ND NORSK DATA	ENGINEERING CHANGE ORDER	PAGE 1 OF 6 .
	ECO NO.: 100-770

VALID FOR	PART NOs. : 350344 VERSIONS : AA NAME : NCP-1 PLUGBOARD PRINT NOs.: 5294 ND NOs. : --
NEW VERSION	PART NOs. : 350344 VERSIONS : BA NAME : NCP-1 PLUGBOARD
SYMPTOMS	DESIGN CHANGE: Signals involved are already terminated elsewhere.

ECO: 100-770 P. 3 OF 6

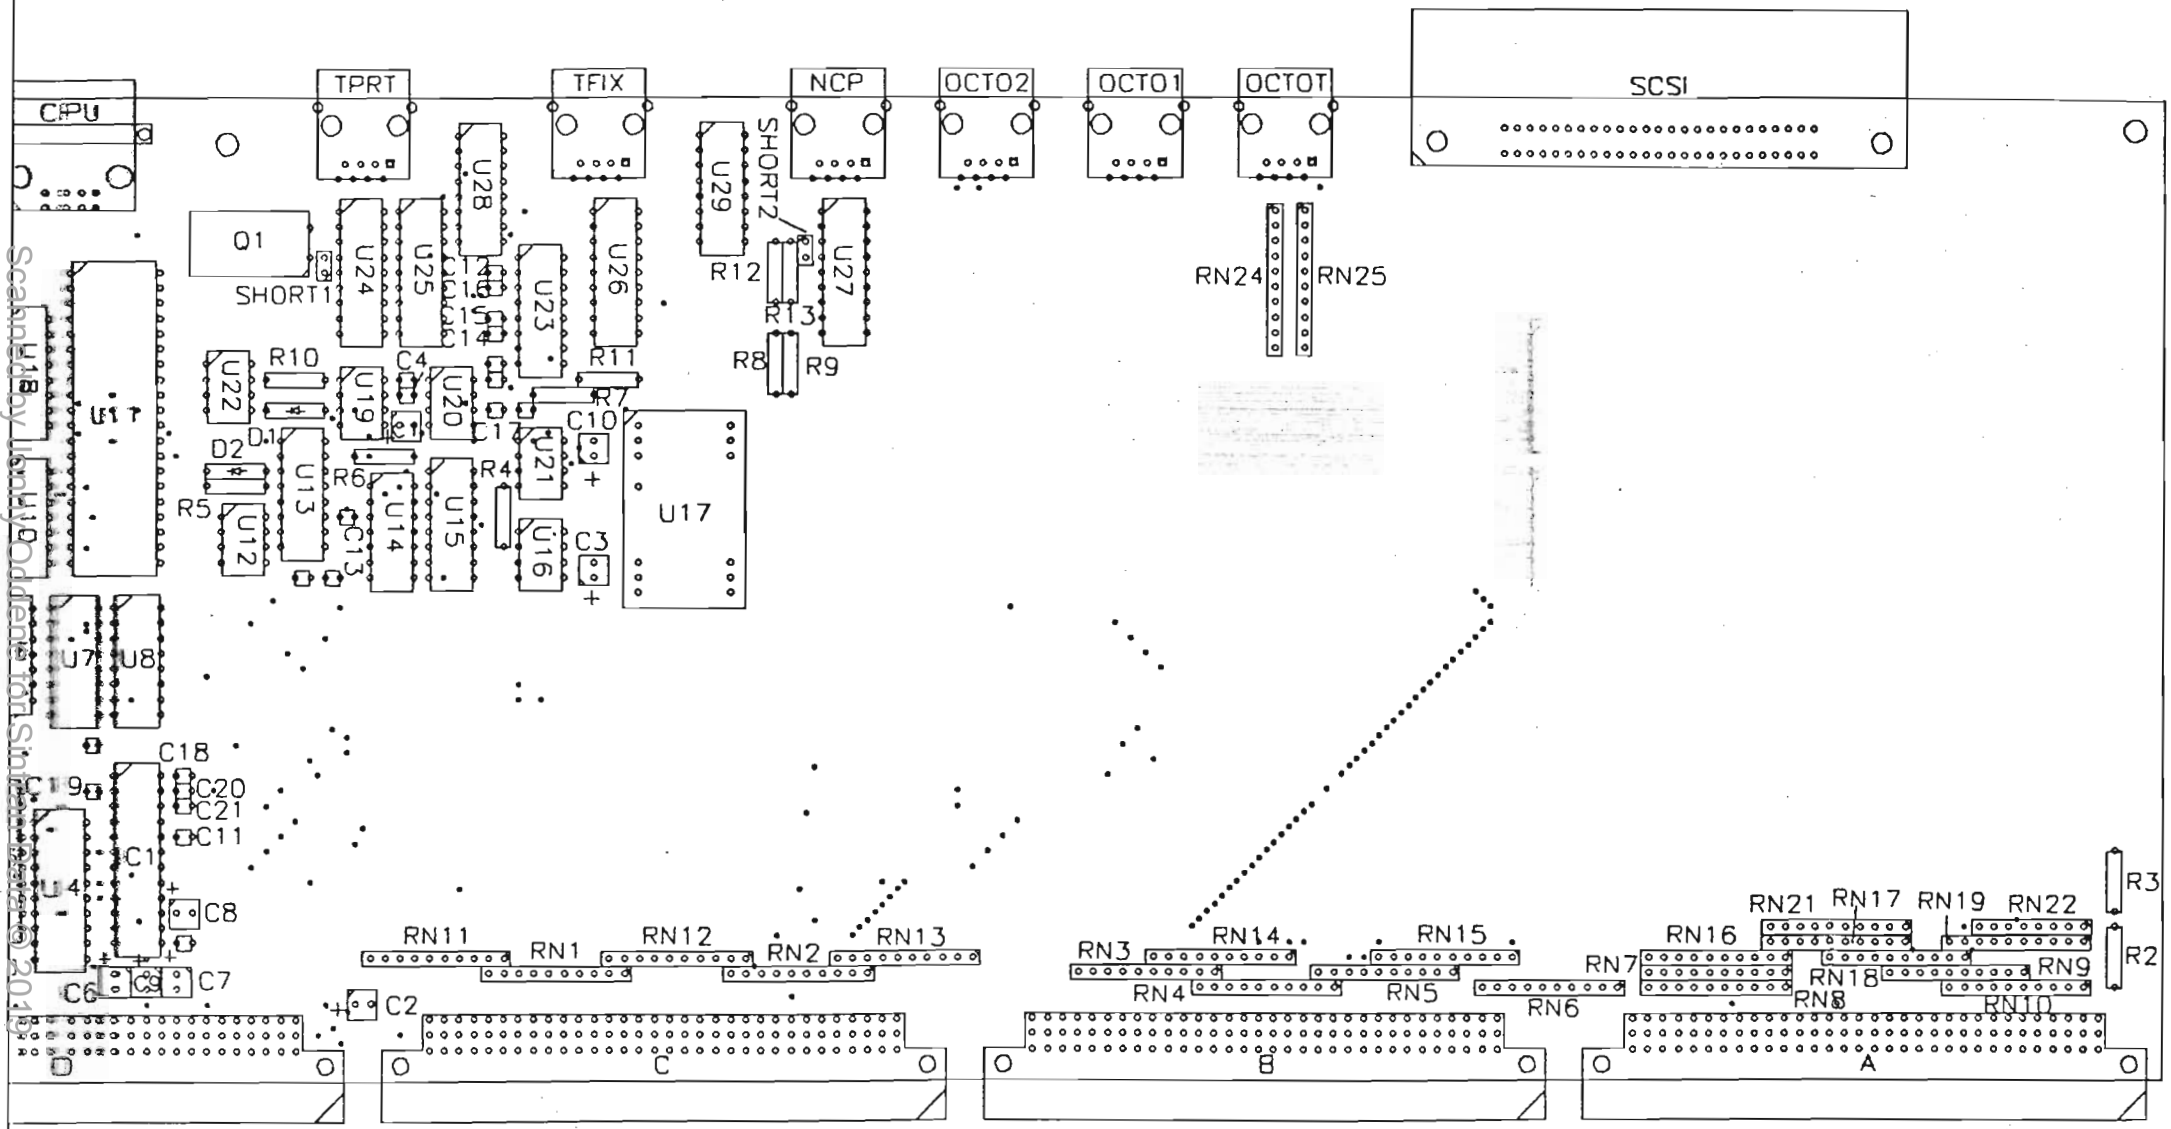
Remove resistor 330 ohm R 2
Remove resistor 470 ohm R 3

Remove resistor network RN 1
RN 2
RN 3
RN 4
RN 5
RN 7
RN 8
RN 9
RN 10
RN 11
RN 12
RN 16
RN 17
RN 18
RN 19
RN 21
